Response to Anonymous Referee 6

R6-1: We understand the concern by Referee 6. Our study is conditional on earthquake scenarios falling within a specific range of magnitude, and does not address on the occurrence probability of these events nor cover the entire range of the magnitude. In the revised manuscript, we change the paper title to: '*Uncertainty quantification of tsunami inundation in Kuroshio Town, Kochi Prefecture, Japan using the Nankai-Tonankai megathrust rupture scenarios*'.

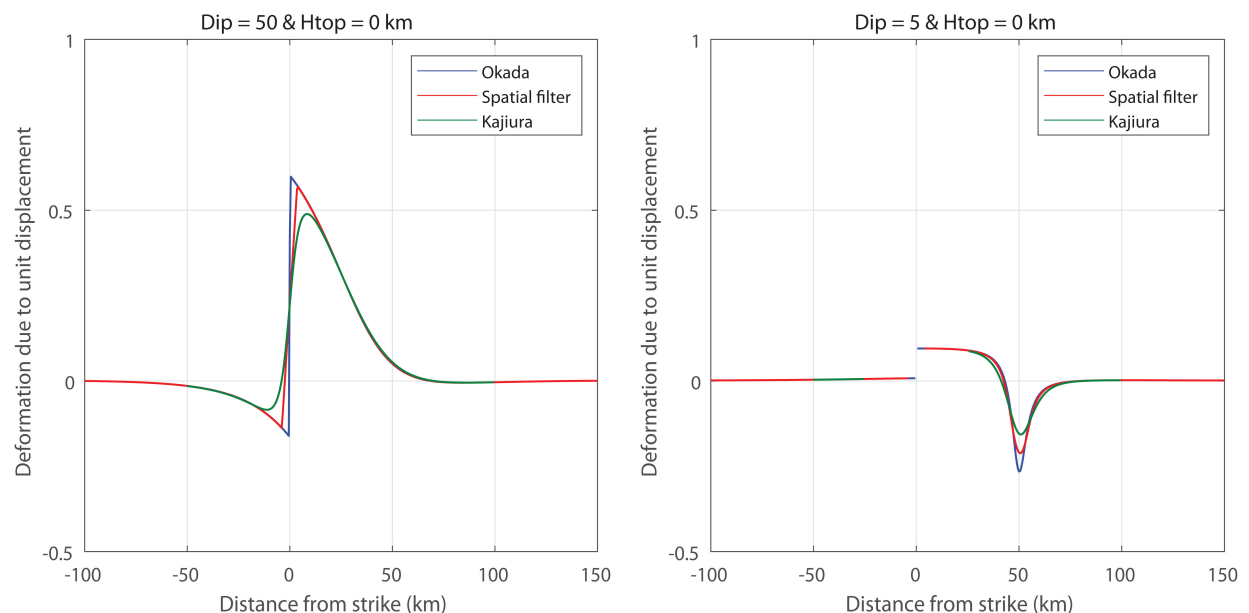
Q6-7: Line 244: Spatial smoothing 9-by-9. Why "9-by-9"? Looks grid-dependent. Any benchmarking against Kajiura or Nosov&Kolesov methods?

R6-7: This simple spatial smoothing filter was used by the Cabinet Office. This is the main reason that we also used the same filter function. We applied the filter at 810-m grid resolution, which is the same as the approach suggested by the Cabinet Office.

Regarding the spatial filtering of deformation profiles, we compare the Okada deformation (vertical only), spatial filtered deformation (15-grid size with 0.5 km grid size, which is approximately similar to 9-grid size filter with 0.81 km grid size), and Kajiura filtered deformation. To make a suitable reference to the published paper, we used the same rupture scenario as considered by Glimsdal et al. (2013). More specifically, the rupture scenario is: unit reverse displacement of a rectangular fault with $L = 100$ km and $W = 50$ km. The dip angle is set to 50 degrees and the top of the depth is set to 0 km (i.e. surface rupture). Glimsdal et al. compared the Okada-based cross-section profile with the Kajiura-based cross-sectional profile for this rupture (see Figure 2 in their paper). In addition, a comparison for dip = 5 degrees (representing a shallowly-dipping reverse fault rupture, like subduction events) is also included in the figure below.

The spatial filter that is used in this study has less significant than the Kajiura filter (red versus green). Note that when the spatial filter size is doubled, the spatial filter and the Kajiura filter become more similar in profile and amplitude. Therefore, in our calculations, sharper deformation profiles are used, compared with the Kajiura filter. We emphasize that the set-up for the spatial filter is the same as in the Cabinet Office's model and we wanted to use the same set-up for our investigations.
